DURHAM COUNTY

I-40 and Miami Blvd.

Date: April 4, 2017	County: Durham
Interchange: I-40 and Miami Blvd.	
Location (exit ramp): EB Exit Ramp

I-40 EB Exit Ramp at Miami Blvd.

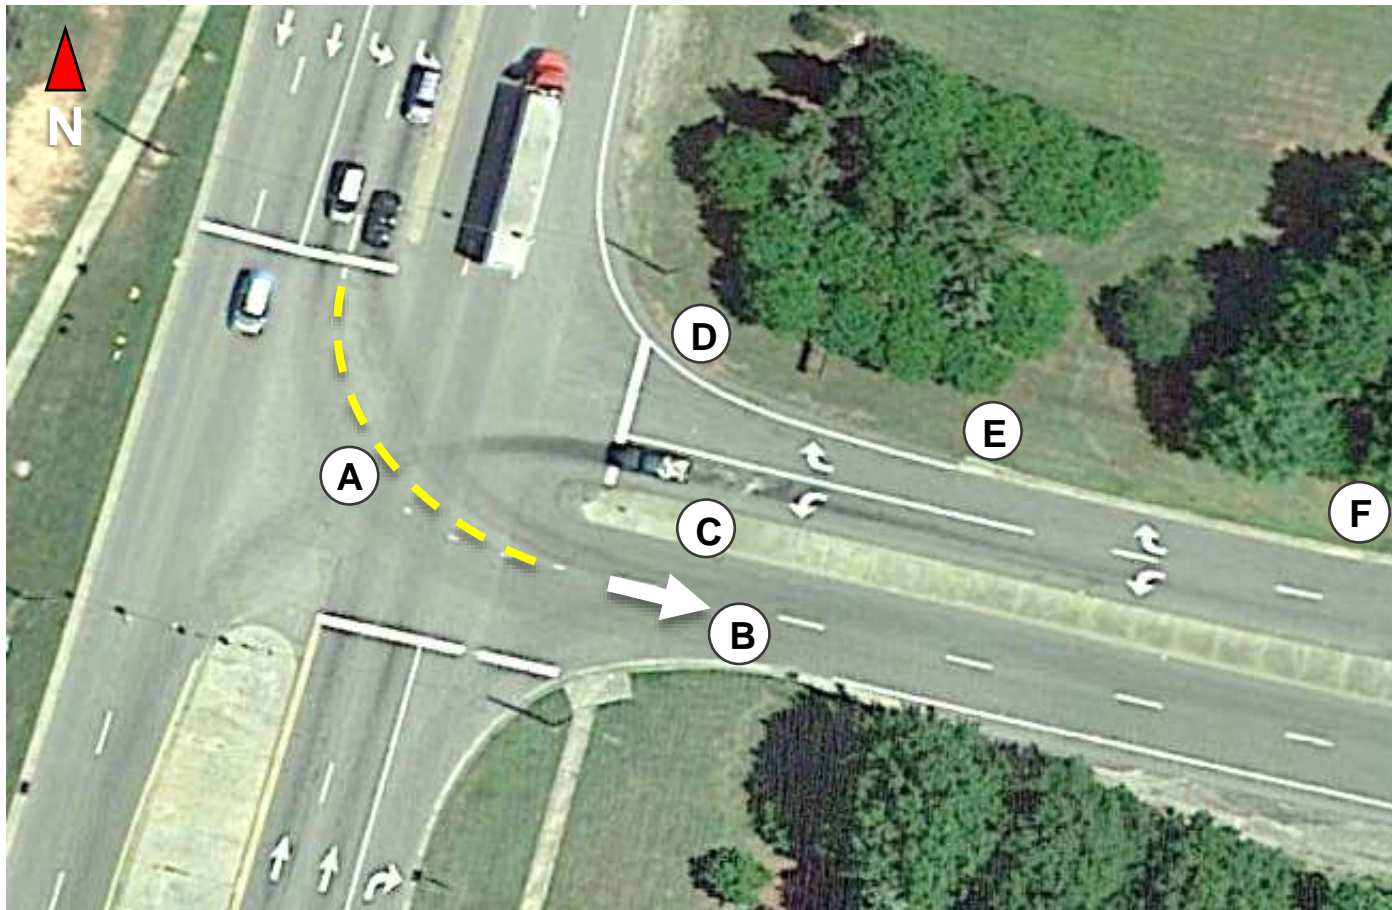
Feature	Presence	Visibility and Notes	Potential Modifications
Wrong way sign	N		Add sign
Wrong way arrows	N		Add arrow
Do not enter sign	Y	Poor visibility at night	Move closer to intersection
One way	N		
No right turn	NA		
No left turn	NA		
Freeway entrance signs	N		Add signs
Dashed turning guide lines	N	Completely faded	Re-paint guide lines
Stop bar at end of exit ramp	Y		
If entrance and exit ramps are directly adjacent to each other:			
Median between	Y		
Splitter sign on median between	Y	Small and short sign	Increase height and size of sign
Barrier between	N

- A. Add dotted lane line extension through intersection**
- B. Add arrow indicating correct freeway entrance point**
- C. Install larger island splitter sign**
- D. Add Do Not Enter sign**
- E. Add Wrong Way sign**
- F. Add Wrong Way arrows**

I-40 WB Exit Ramp at Miami Blvd.

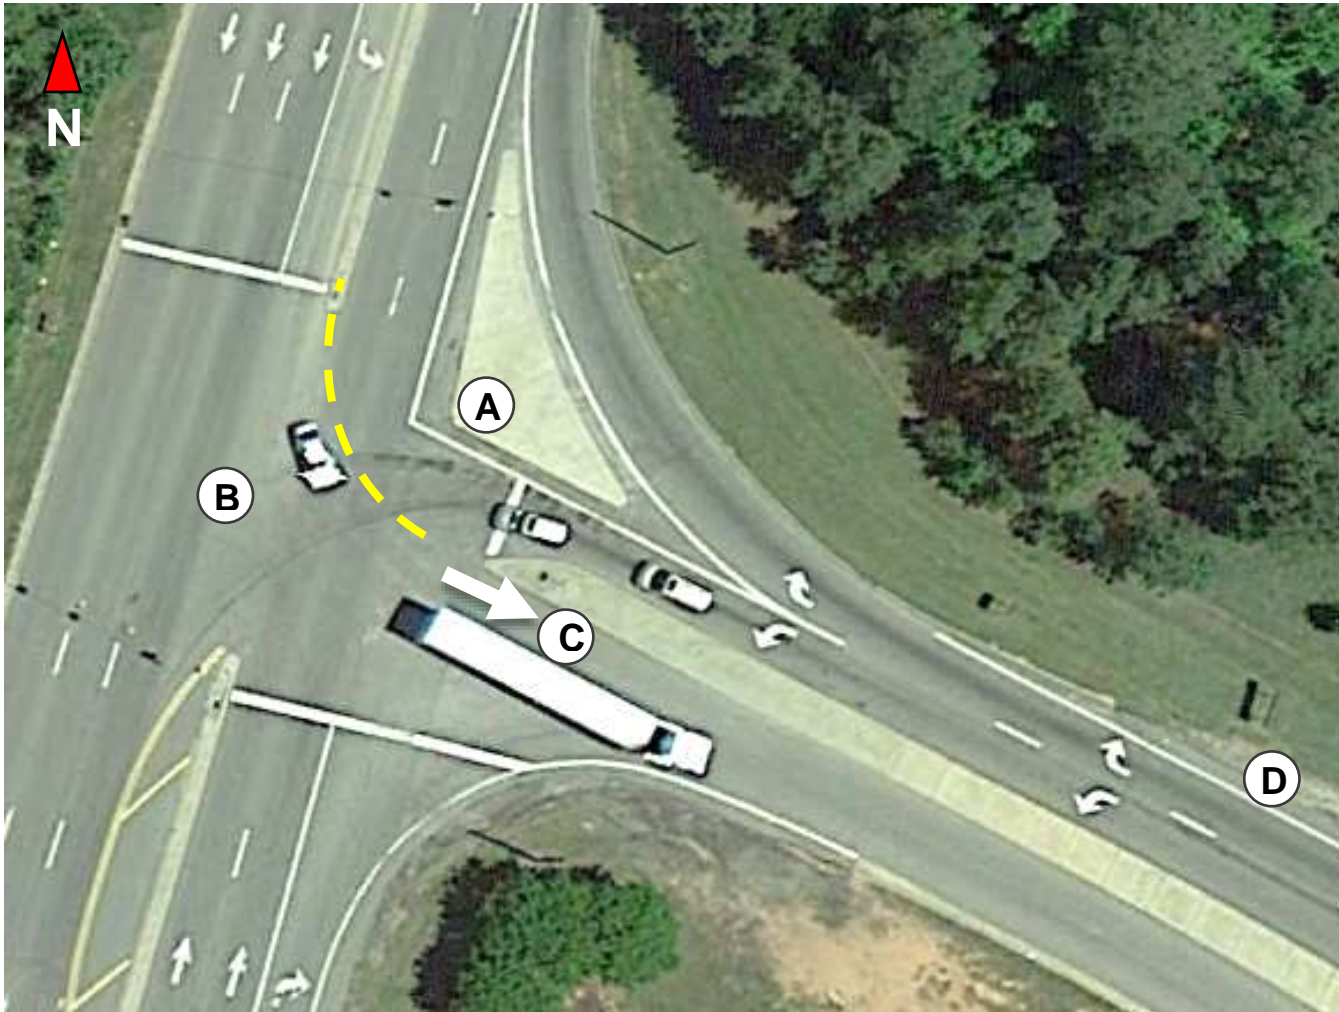
Feature	Presence	Visibility and Notes	Potential Modifications
Wrong way sign	Y		
Wrong way arrows	N		Add arrows
Do not enter sign	Y		Add sign at splitter island
One way	N		
No right turn	NA		
No left turn	NA		
Freeway entrance signs	N		
Dashed turning guide lines	N		Add guide lines
Stop bar at end of exit ramp	Y		
If entrance and exit ramps are directly adjacent to each other:			
Median between	Y		
Splitter sign on median between	Y		
Barrier between	N

- A. Add Do Not Enter sign to splitter island
- B. Add dotted lane line extension through intersection
- C. Add arrow indicating correct freeway entrance point
- D. Add wrong way arrows

I-85 NB Exit Ramp at E. Club Blvd.

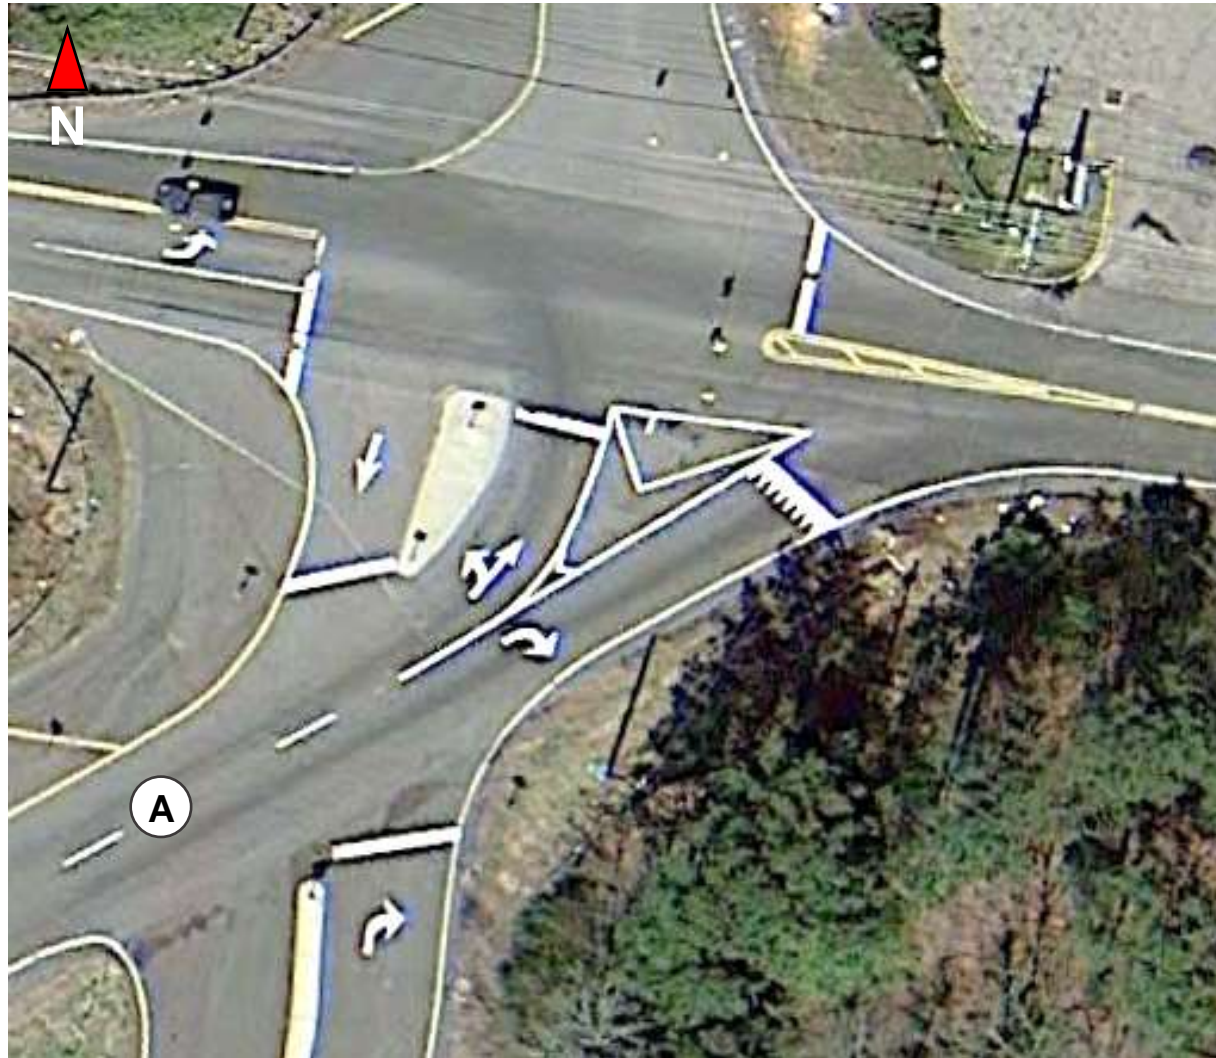
This exit ramp terminal is strangely and potentially dangerously configured, in that it allows a movement onto the ramp that is counterflow to most of the ramp. This movement is apparently to provide access to the private driveway that accesses the ramp. This counterflow movement is accentuated by the placement of a pavement arrow which seemingly directs drivers to enter the exit ramp.

A. Add Wrong Way arrows

US 70 EB Exit Ramp at Cheek Rd.

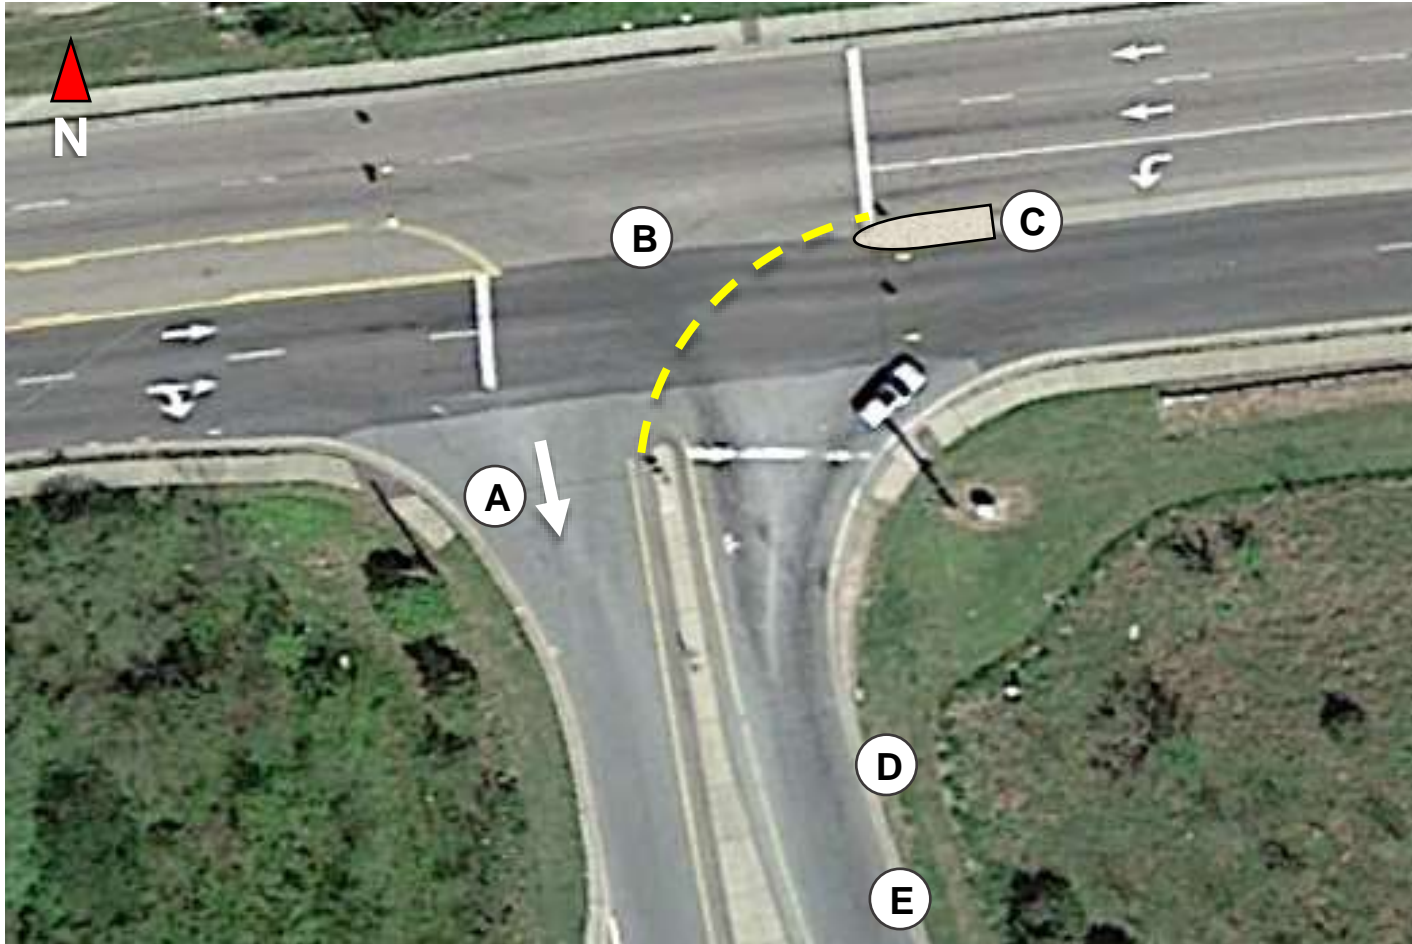
Feature	Presence	Visibility and Notes	Potential Modifications
Wrong way sign	N		Add sign
Wrong way arrows	N		Add arrows
Do not enter sign	Y		
One way	Y		
No right turn	NA		
No left turn	NA		
Freeway entrance signs	N		
Dashed turning guide lines	N		Add guide lines
Stop bar at end of exit ramp	Y		
If entrance and exit ramps are directly adjacent to each other:			
Median between	Y		
Splitter sign on median between	Y		
Barrier between	N

- A. Add arrow indicating correct freeway entrance point
- B. Add dotted lane line extension through intersection
- C. Extend raised median
- D. Add Wrong Way sign
- E. Add Wrong Way arrow

US 70 WB Exit Ramp at Holloway St.

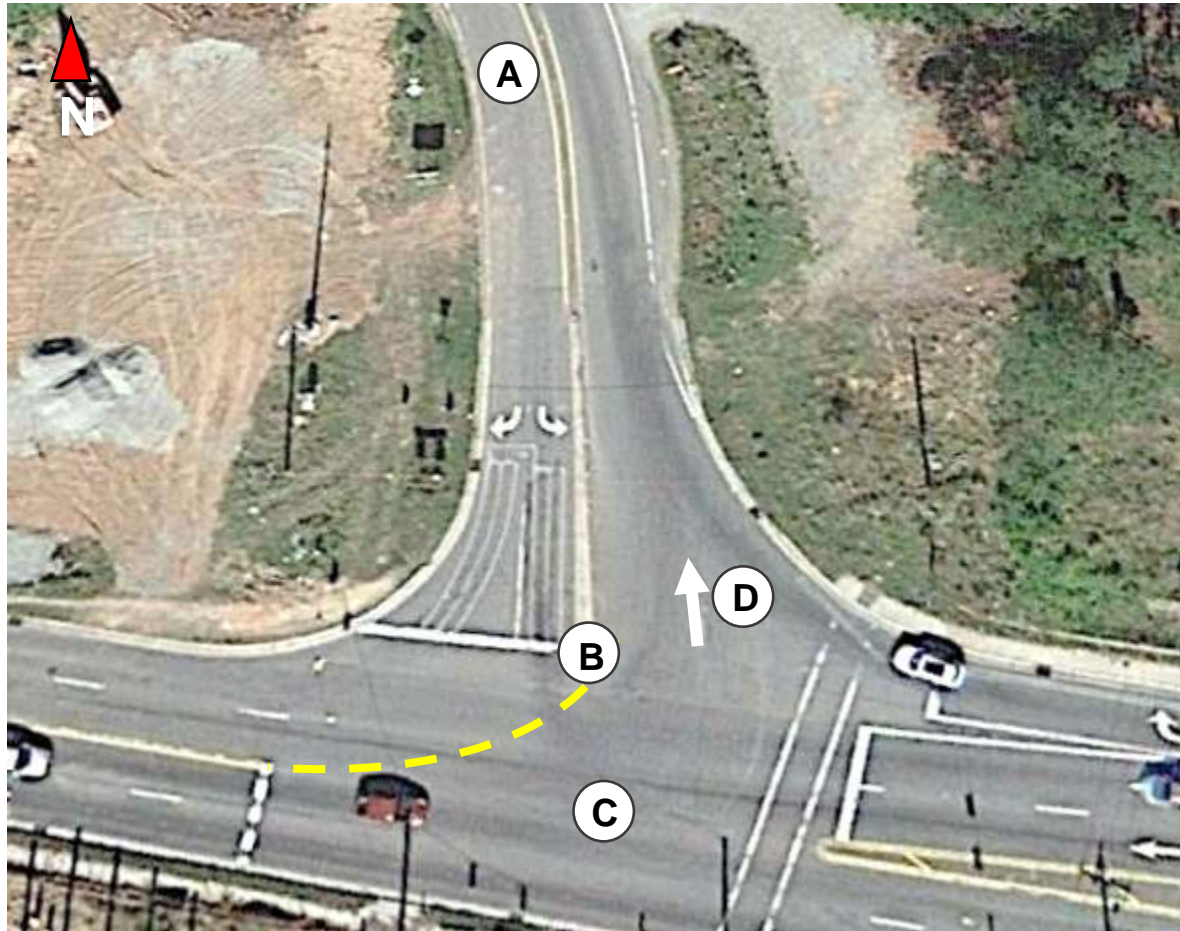
Sight line clutter – buildings, overpass, and signs converge, creating heavy visual stimuli

Improve visibility of the median on the exit/entrance ramp

- A. Add wrong way arrows**
- B. Improve median visibility, add splitter sign**
- C. Add dotted lane line extension through intersection**
- D. Add arrow indicating correct freeway entrance point**

I-40 EB Exit Ramp at Fayetteville Rd.

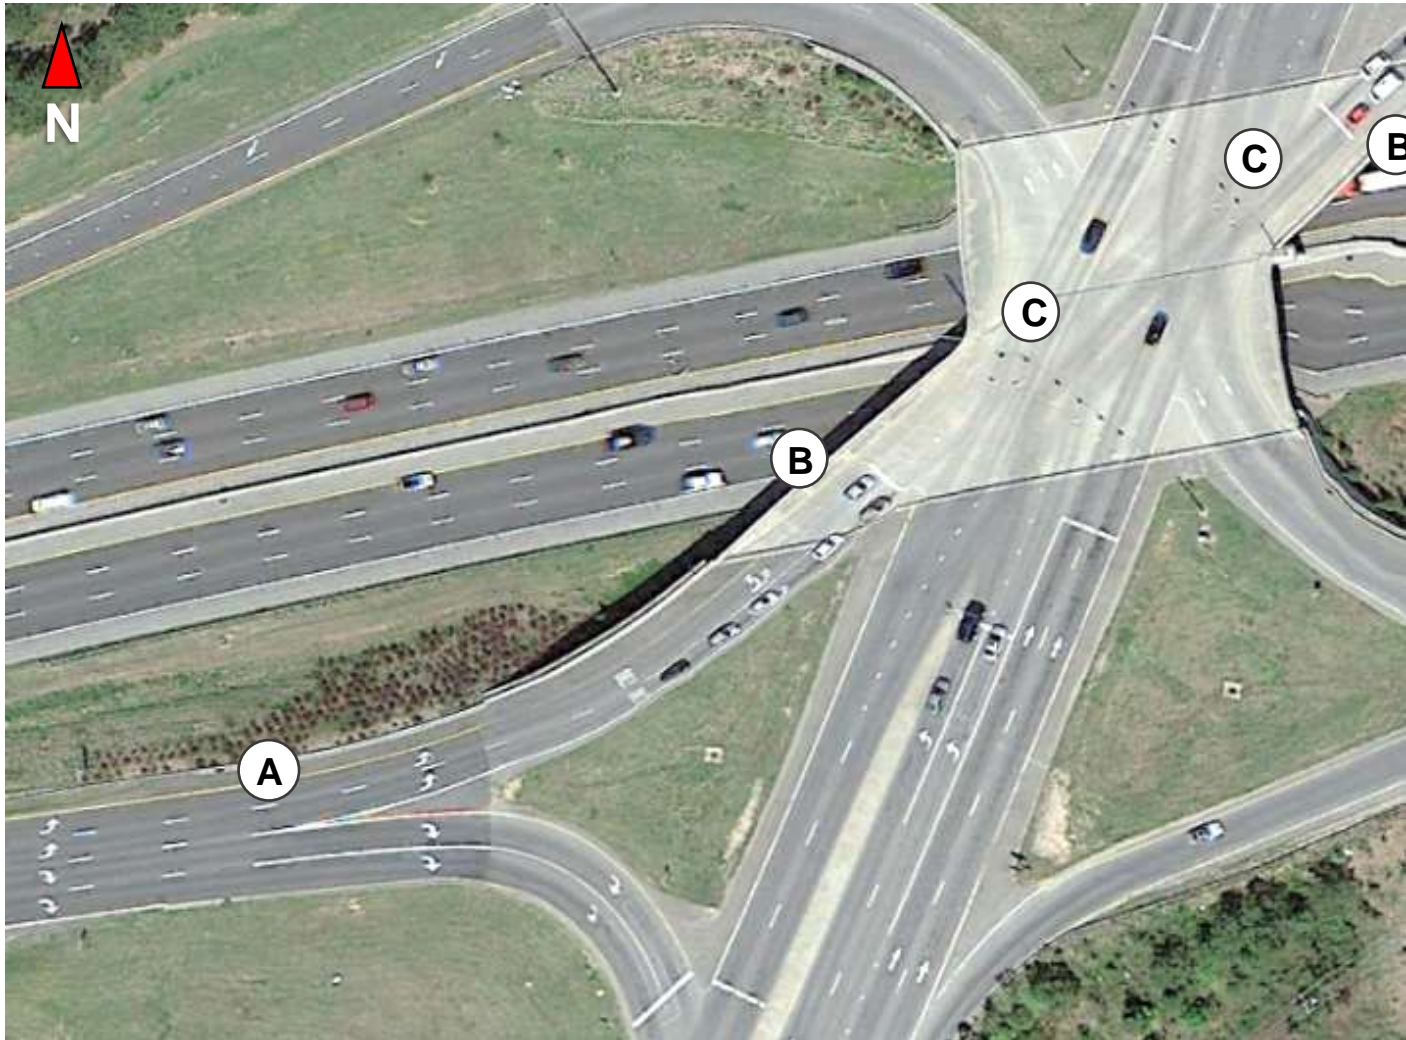
Some form of overhead 'Do Not Enter' sign may be appropriate above the directional lanes of the exit ramp. These could be similar to the static metal signs (i.e., circular with the words "Do Not Enter"), or could be configured as red X's, similar to the type of signs used on roads with changeable direction lanes.

- A. Add Wrong Way arrows
- B. Add Wrong Way signs
- C. Add overhead signs to indicate 'No Entry'

I-40 Bus. EB Exit Ramp at Cloverdale Ave.

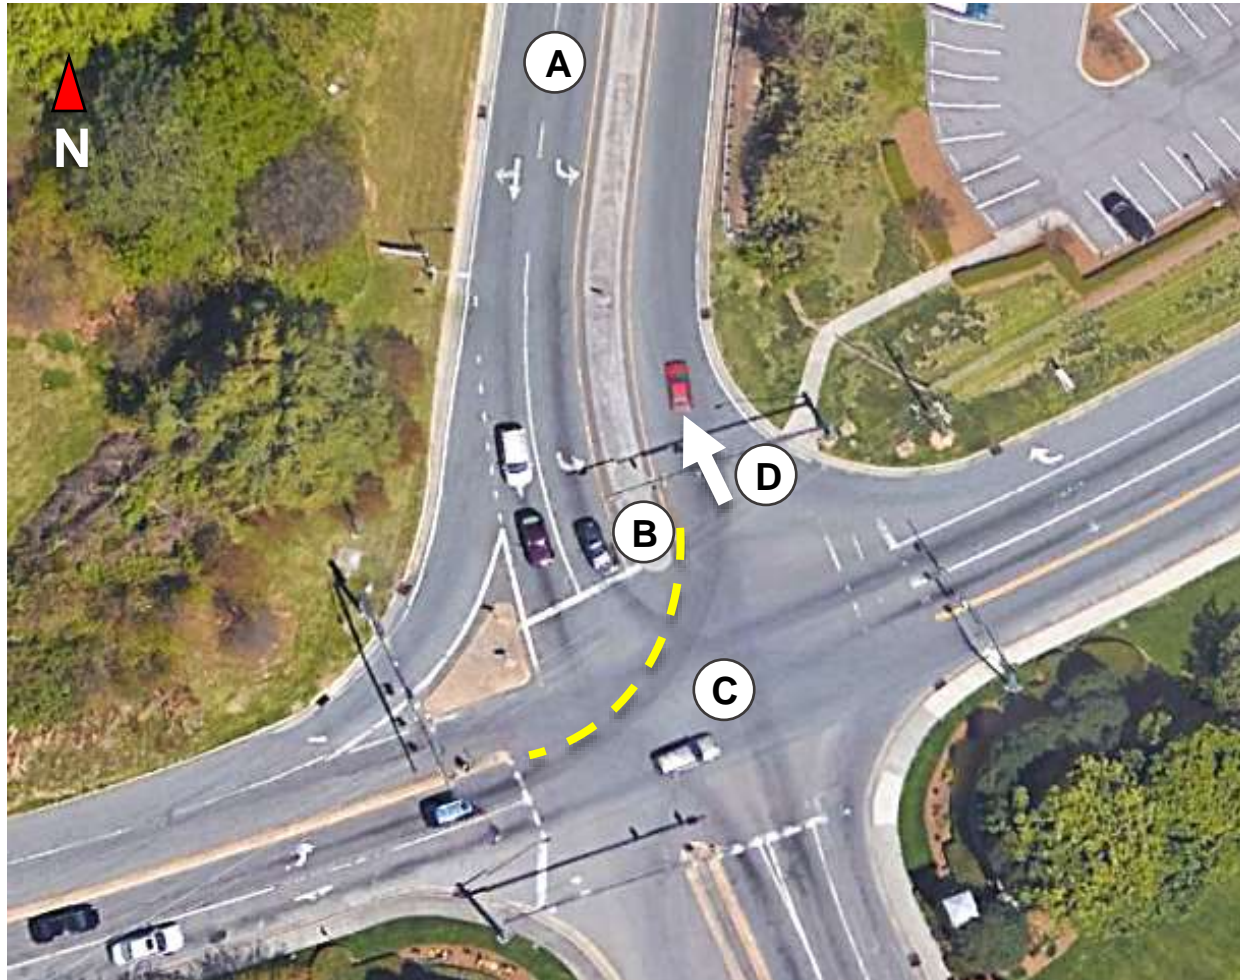
Low potential for right turn wrong-way movement. Left turn wrong-way movement has some potential.

- A. Add Wrong Way arrows
- B. Add reflectors and improve visibility of median
- C. Add dotted lane line extension through intersection
- D. Add arrow indicating correct freeway entrance point

I-40 Bus. WB Exit Ramp at Cloverdale Ave.

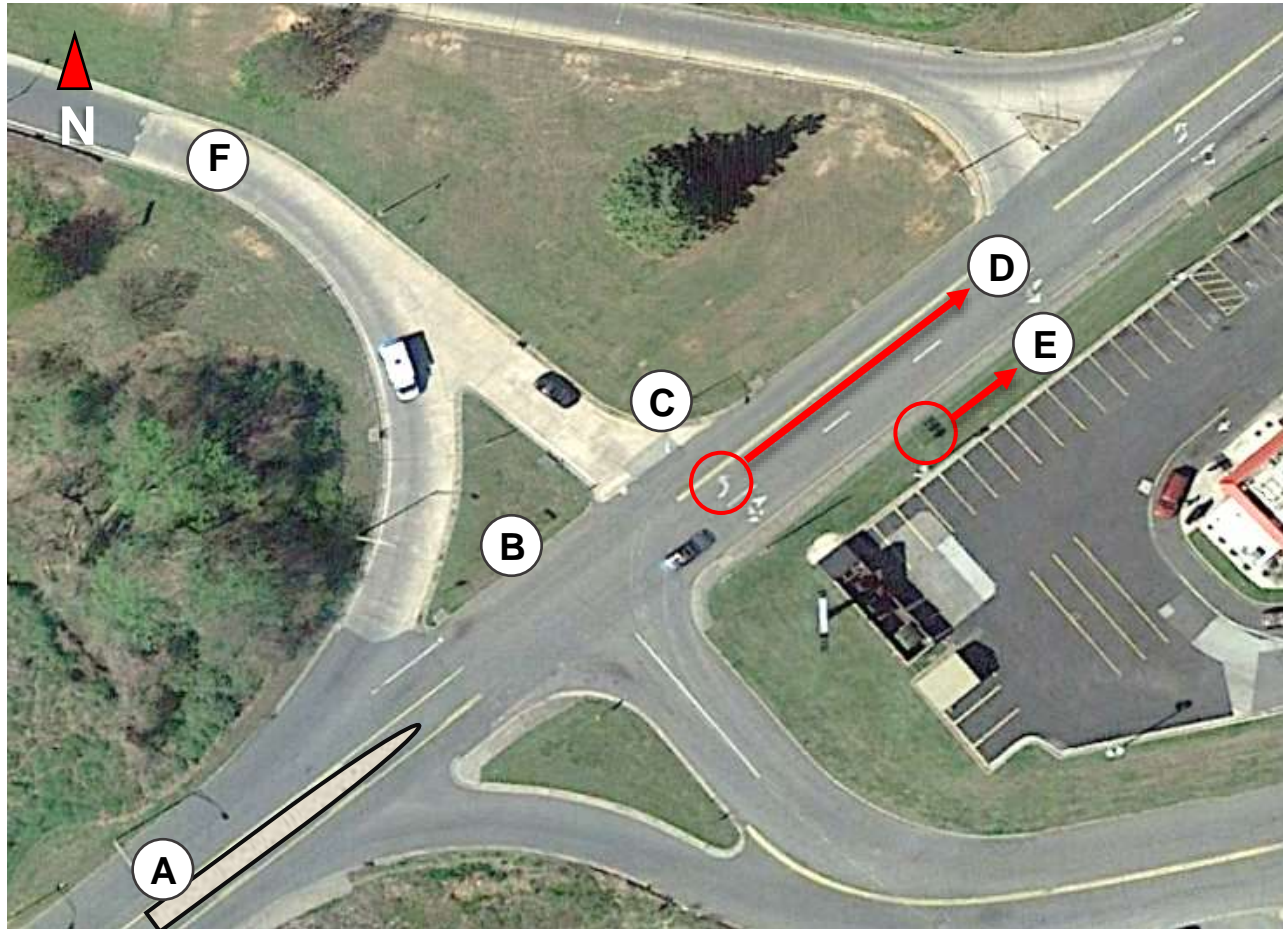
When approaching Northbound on Cloverdale, a driver may not see that the entrance ramp is up ahead (i.e., they only see the exit ramp). Route sign placement does not help (i.e., too close to the exit ramp).

- A. Add raised median to prevent wrong-way entry
- B. Add No Left Turn sign
- C. Tighten corner radius, repaint stop bar, add No Right Turn sign
- D. Remove turn arrow (misleading), move closer to entrance ramp
- E. Move route sign closer to entrance ramp (misleading)
- F. Add Wrong Way arrows
